Comments on Lower Colorado River Authority Fayette Power Project Draft Report

Assessment of Dam Safety of Coal Combustion Surface Impoundments

Sam Seymour - Fayette Power Project Station

Draft Report

FAYETTE POWER PROJECT
LOWER COLORADO RIVER AUTHORITY
LA GRANGE, TEXAS
**FPP ASH POND DAM SLOPE
STABILITY ANALYSIS SECTION A-A'**
FIGURE 10

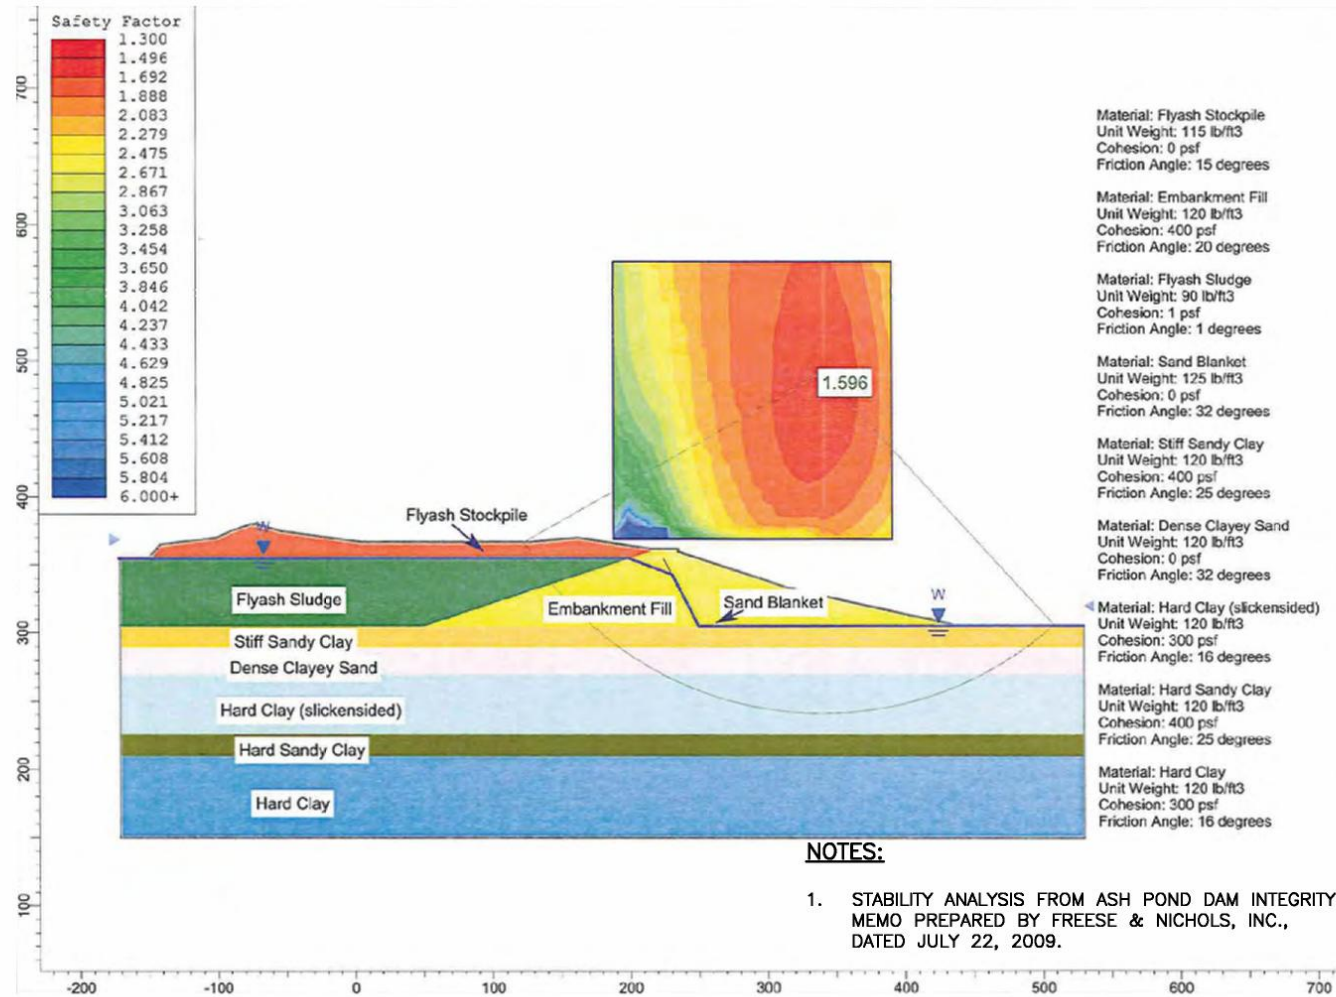
in [Figure 109 and 1149](#) The results on [Figure 109 and 1149](#) indicate the factor of safety against

Comment [k15]: Note incorrect figure reference.
